Report from the October 26 Tracking WG meeting

Back-up Plan development for the ePIC Tracker

Matt Posik, Ernst Sichtermann

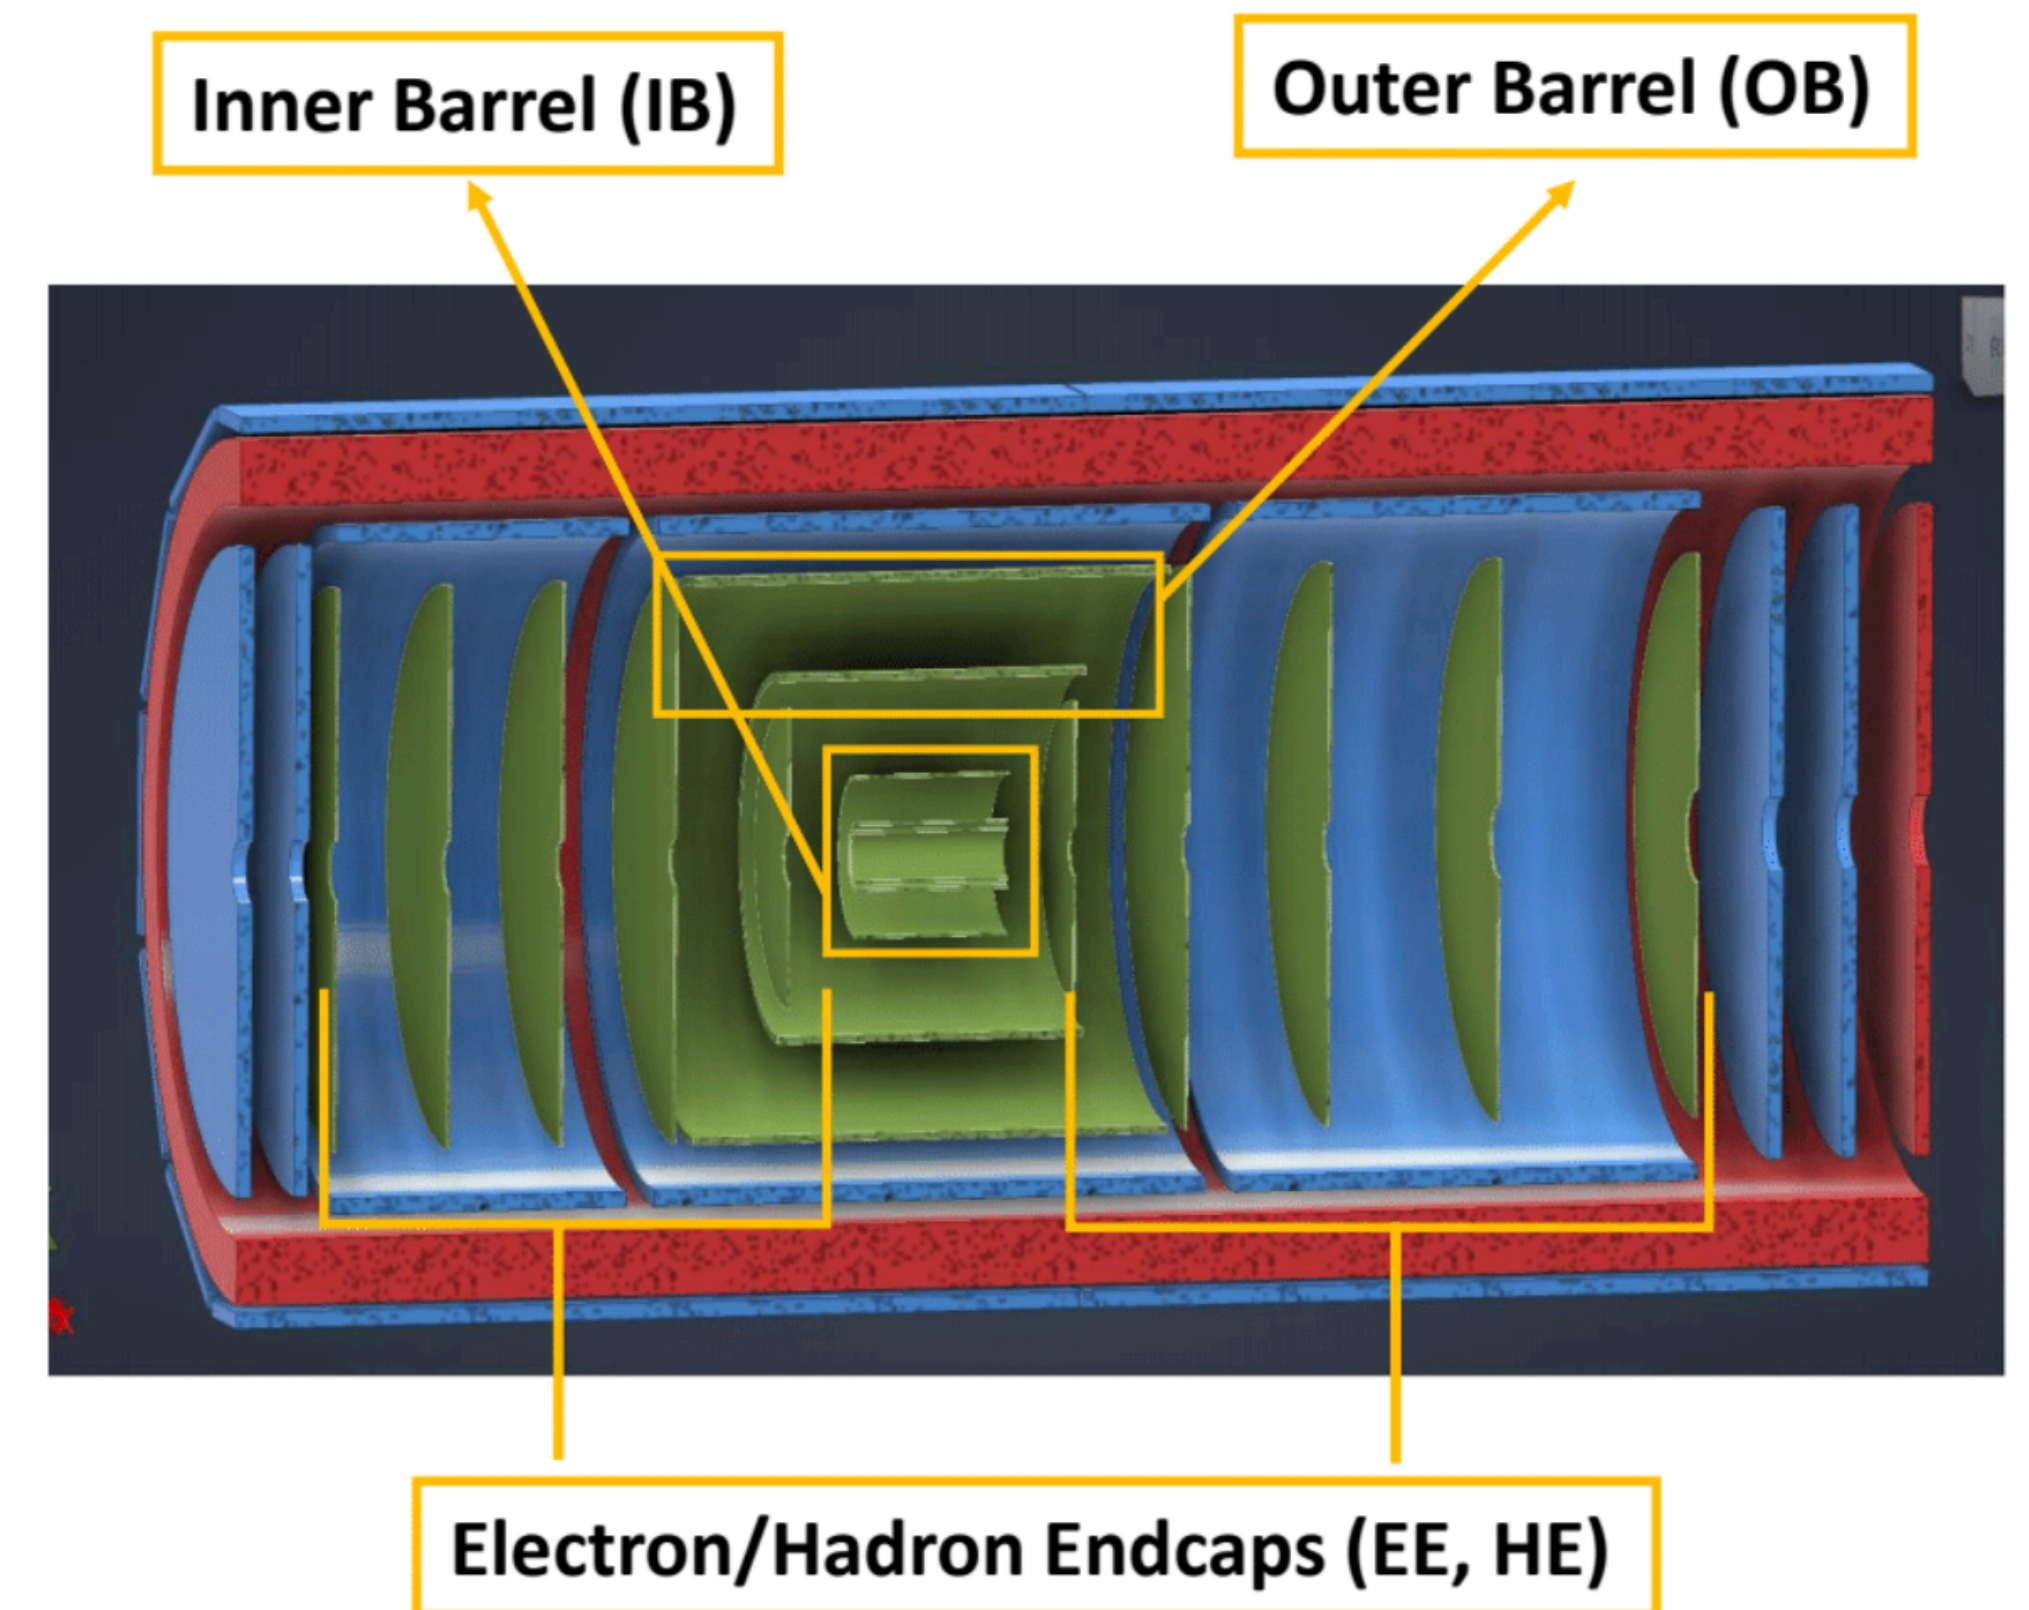
- ITS3 technology works with a timeline compatible with the EIC project timelines, but the EIC-LAS (“fork”) incurs delays that make its timeline incompatible with the EIC project timelines,
- ITS3 technology works but delays are incurred that make its timeline in ePIC incompatible with the EIC project timelines.

- The disks in the Electron and Hadron Endcaps are replaced with MPGD disks derived from the disks of the outer MPGD tracker; nominally, this will then result in 7 (near-)identical MPGD disks on each side,
- The two Outer Barrel layers are replaced with MPGD barrel layers derived from the outer MPGD tracker, specifically its innermost (curved, μ Megas) layer.

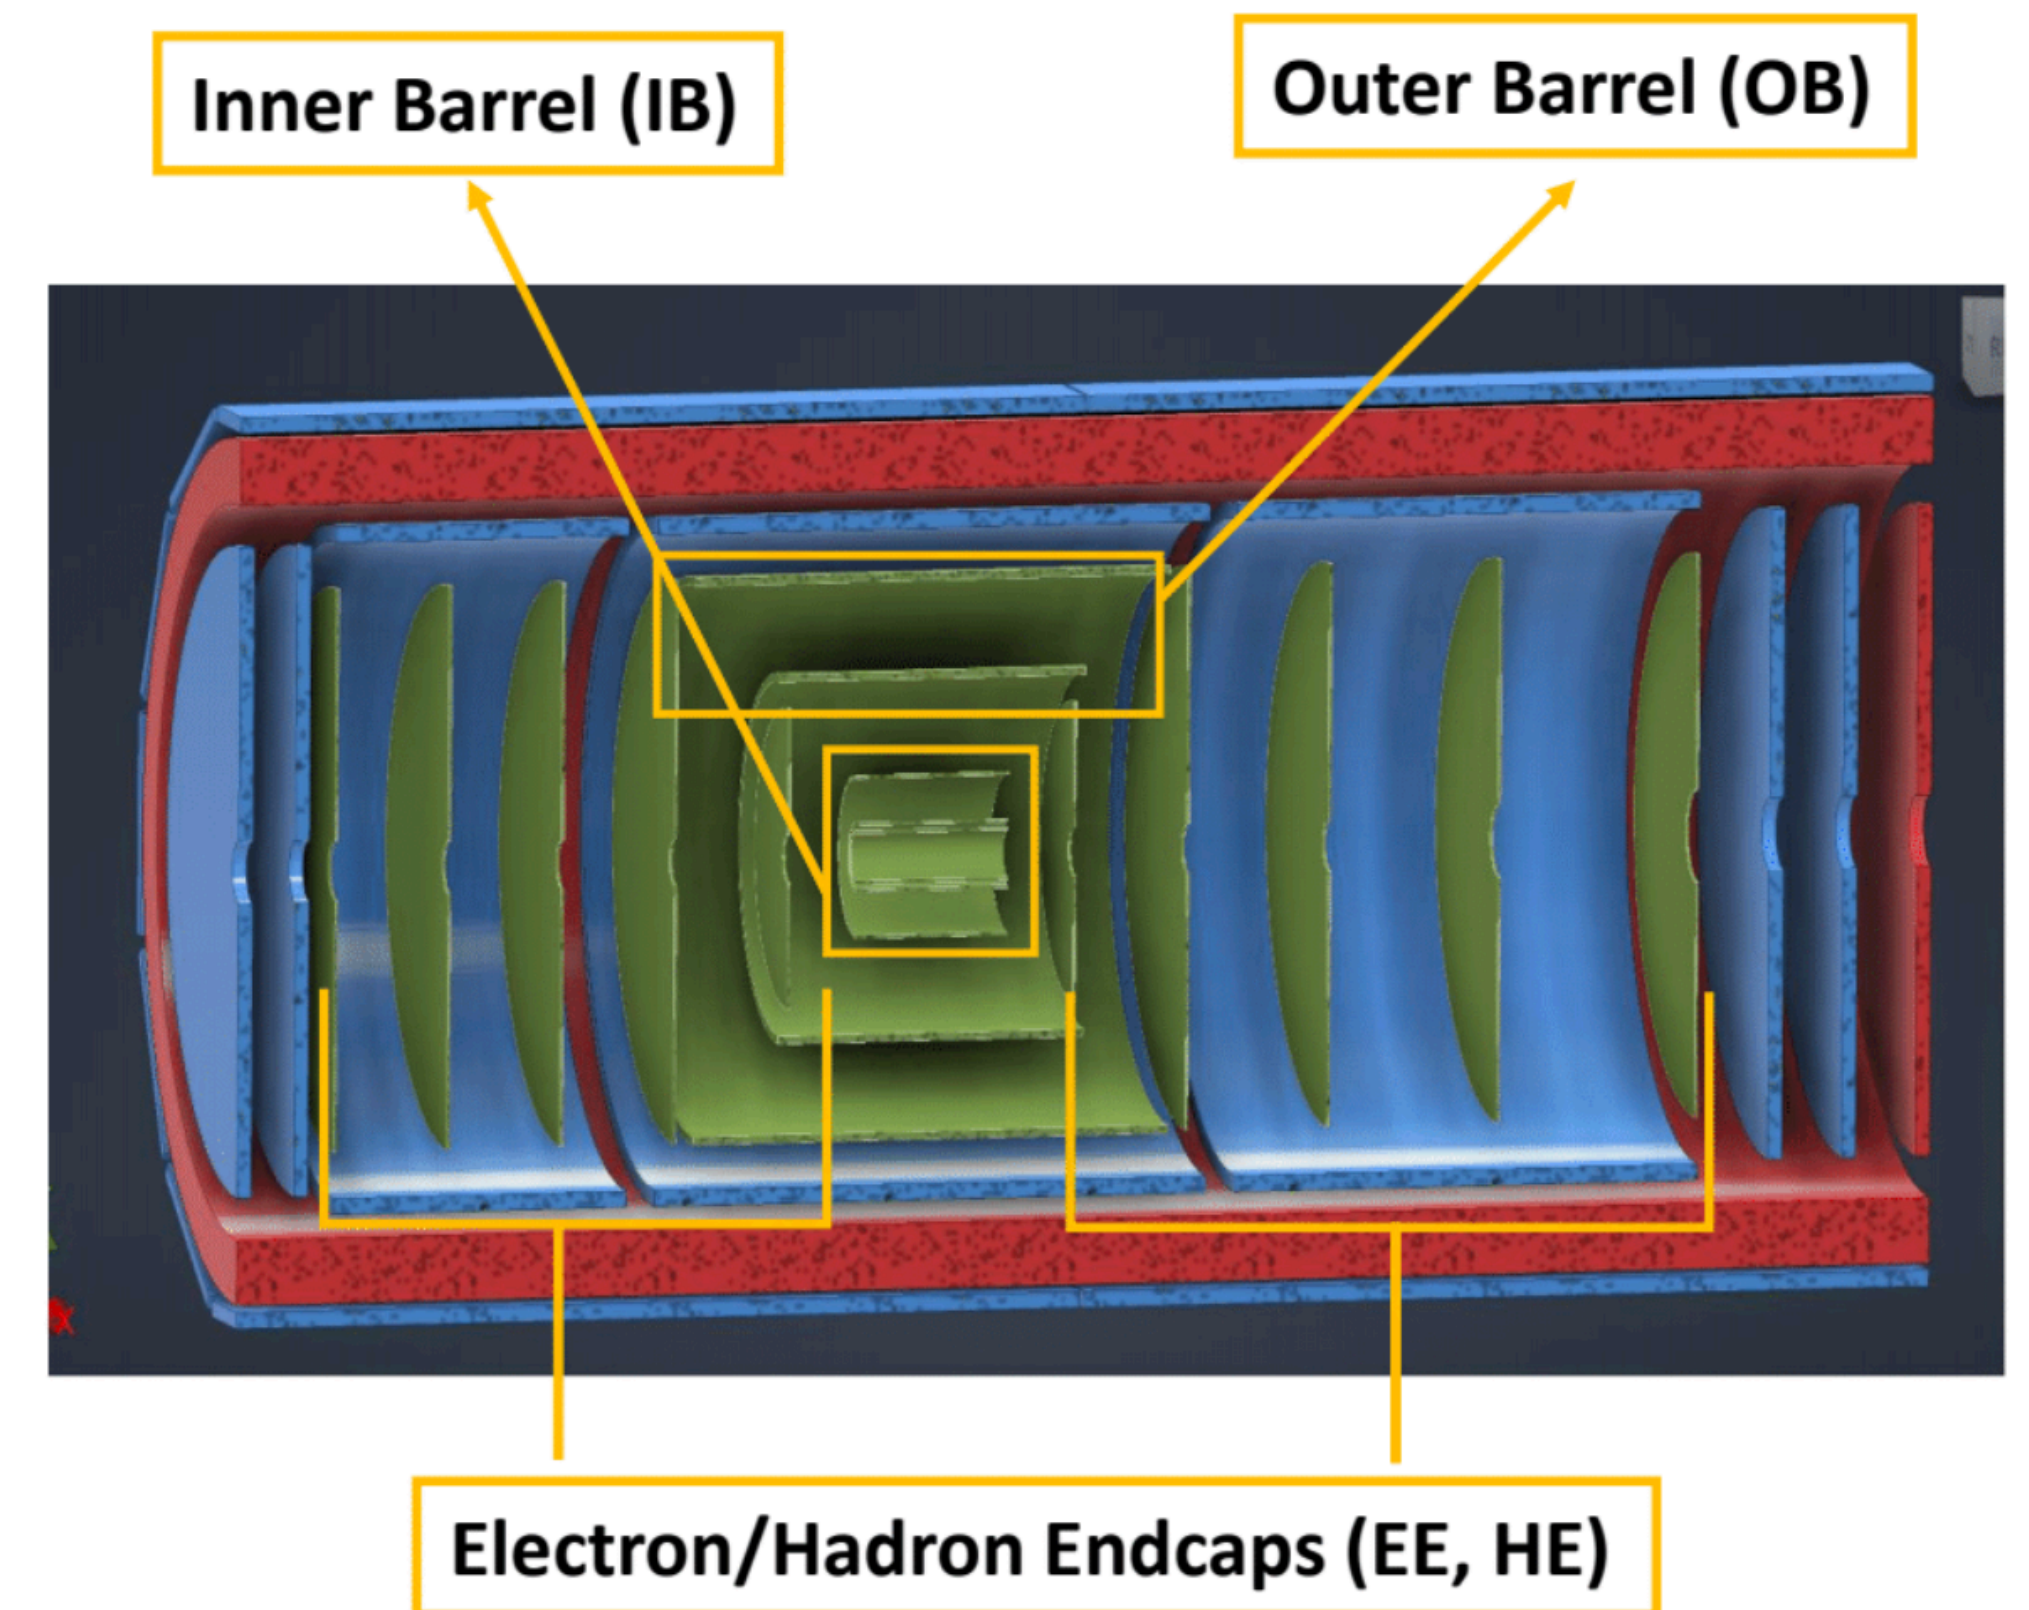
- ITS3 technology works but delays are incurred that make its timeline in ePIC incompatible with the EIC project timelines,

- The Inner Barrel is replaced with two or three layers based on the existing ITS2 sensor, as used in ALICE and sPHENIX without EIC-specific modifications,
- The Outer Barrel and Endcaps are replaced with MPGD barrel and disks as in the first branch point.
